REMARKS

SHIMIZU et al.
Serial No.: 09/722,664
Response to Office Action dated September 2, 2003

Fig. 4

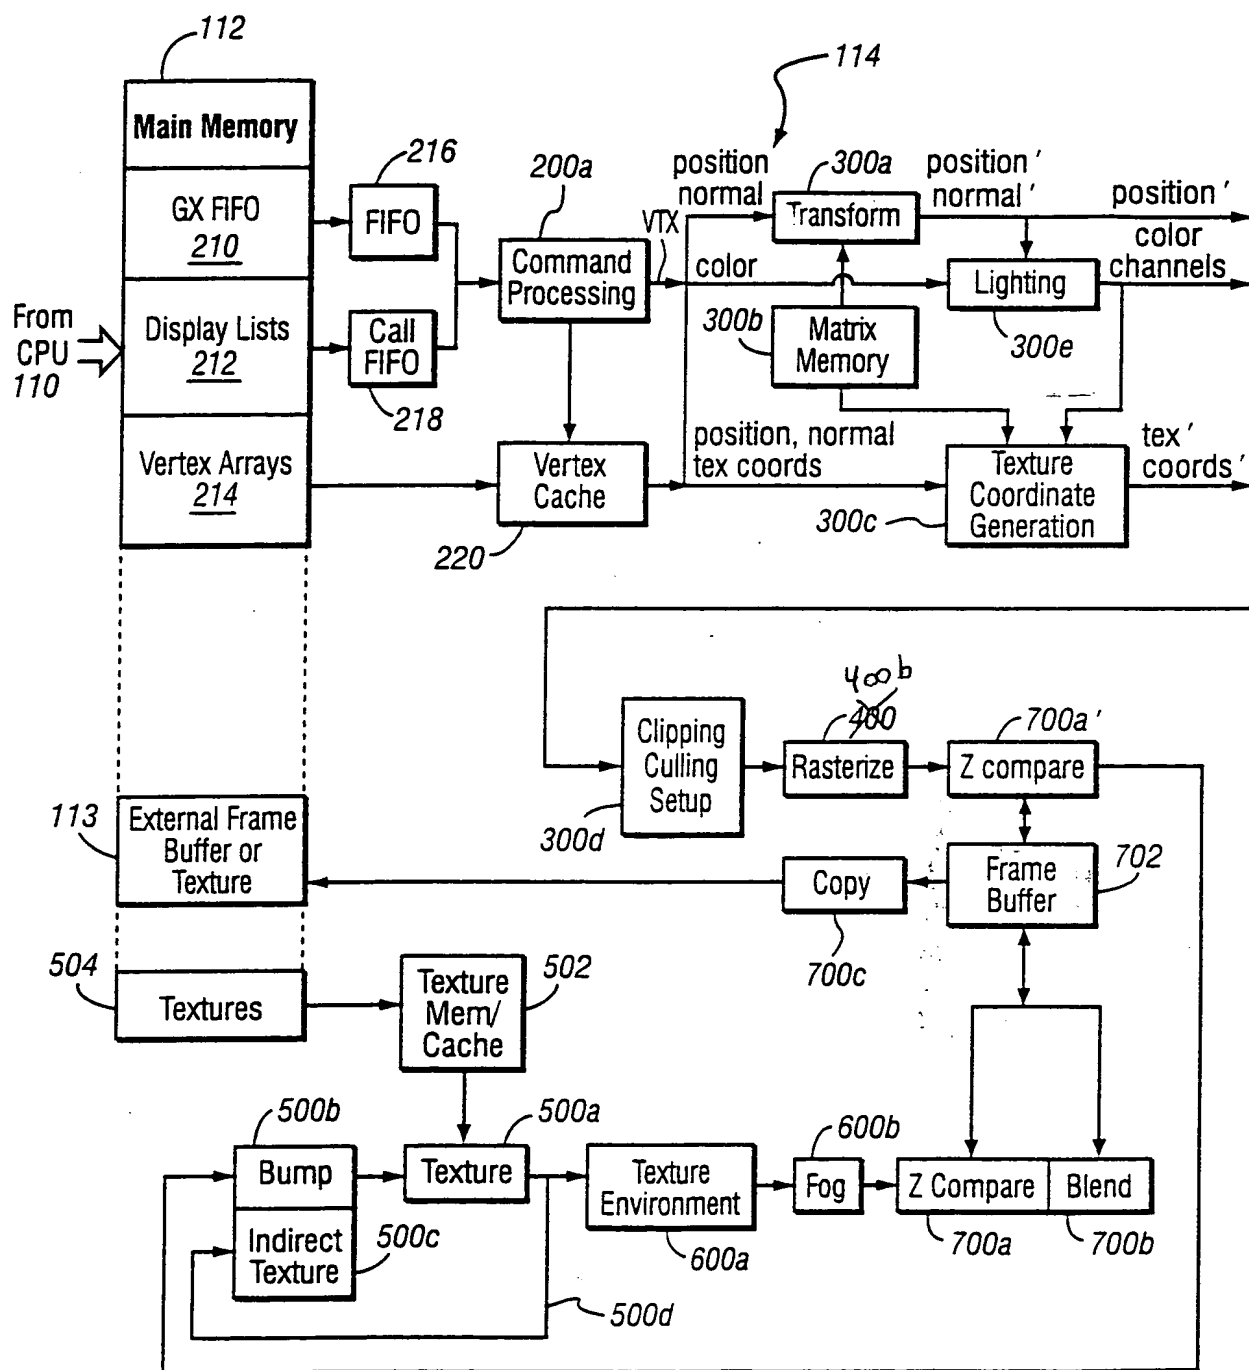
The drawings were objected to as failing to comply with 37 C.F.R. 1.84(p)(4) because the character "130" has been used to designate both the parallel bus in Figure 2 and the Graphics Memory Request Arbitration in Figure 4. In response to this objection, Figure 4 has been changed to designate the Graphics Memory Request Arbitration with the numeral 131. A corresponding change has been made to page 16 of the specification. Based on these changes, withdrawal of the objection under 37 C.F.R. 1.84(p)(4) is respectfully requested.

Fig. 11

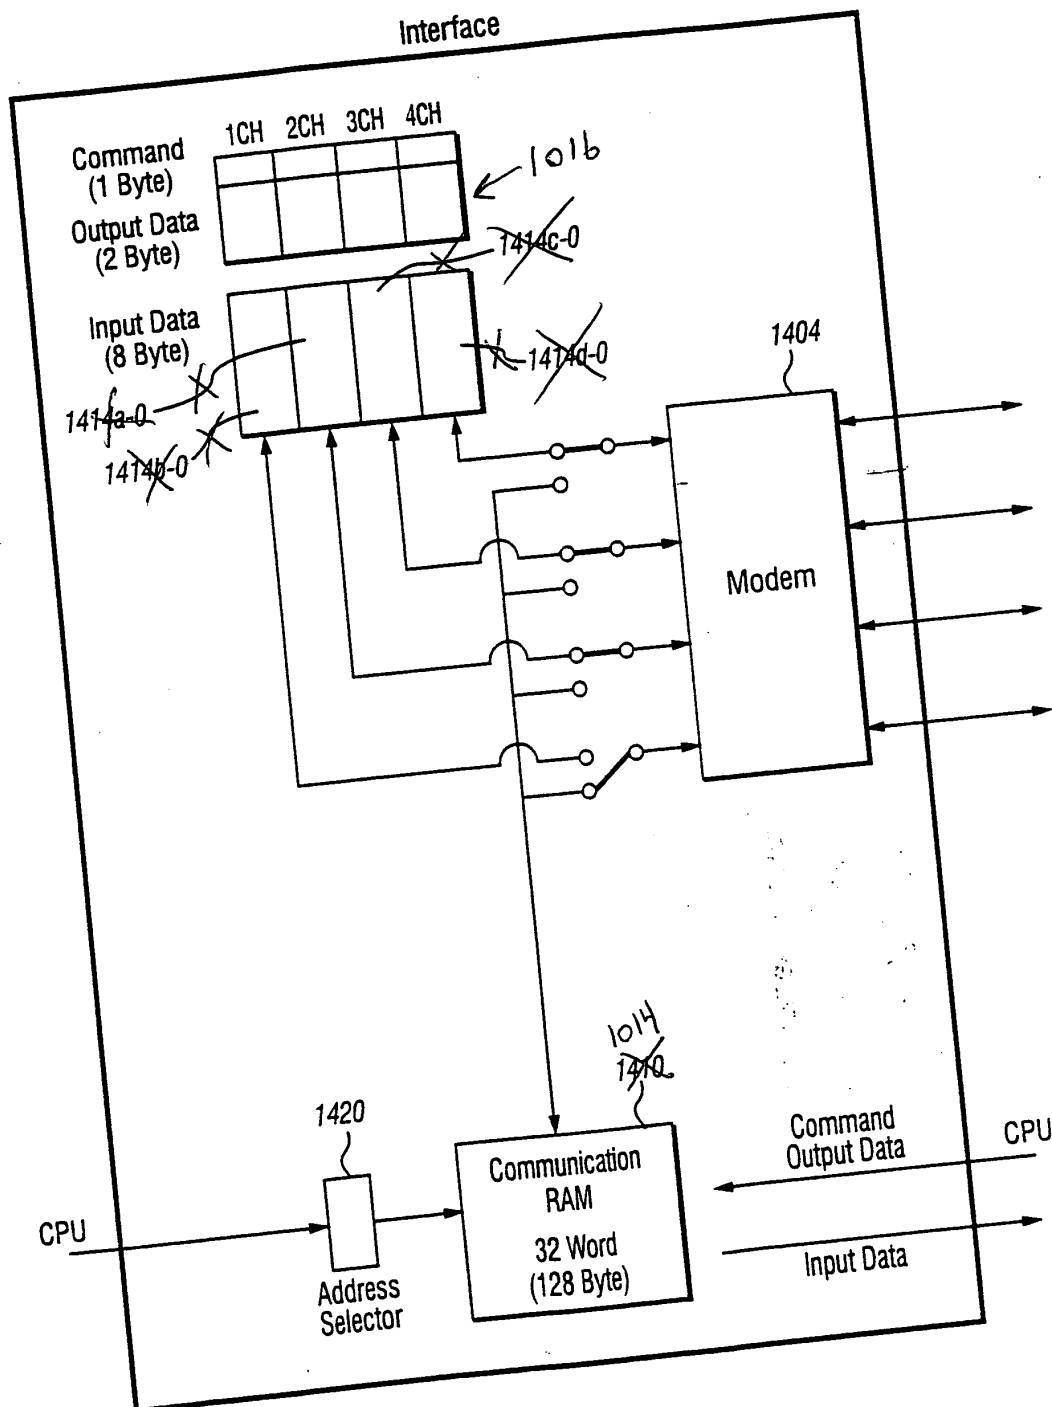
- changed the references in the specification to communication RAM 1410 to communication RAM 1014 and made a corresponding change to Figure 11; and
- changed the reference to input/output buffers 1414 at page 41, line 7 to input/output buffers 1016 and made a corresponding change to Figure 11.

Fig. 17

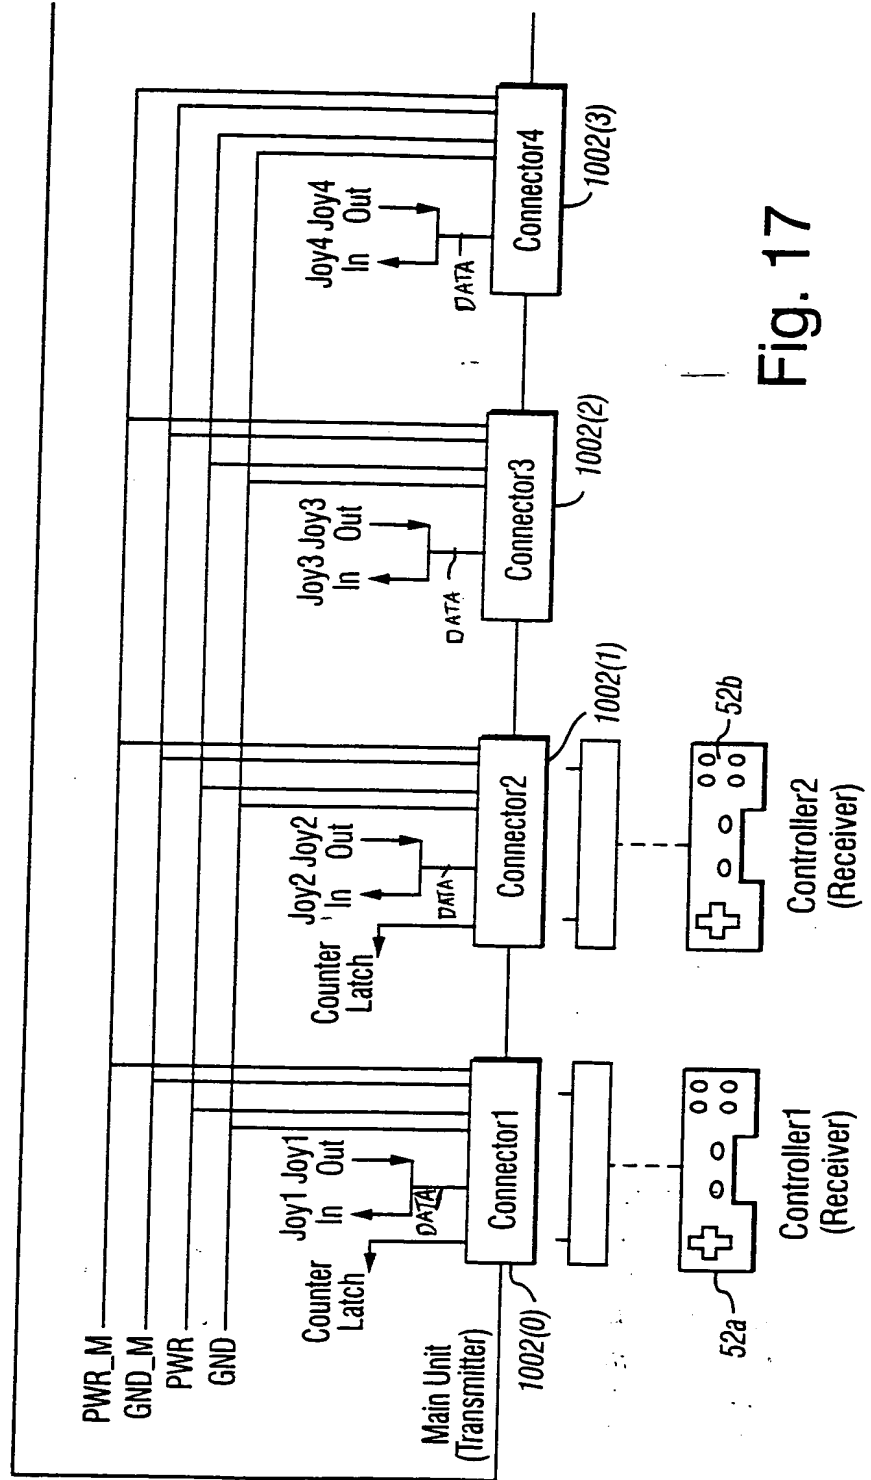
The drawings were objected to as failing to comply with 37 C.F.R. 1.84(p)(5). In response to this objection, Applicants have (1) designated the box labeled "Rasterize" in Figure 5 with the numeral "400b" as described, for example, at page 17, lines 6-9; and (2) identified the DATA lines in Figure 17 as described, for example, at page 45, lines 4-14. Based on these changes, withdrawal of the objection under 37 C.F.R. 1.84(p)(5) is respectfully requested.
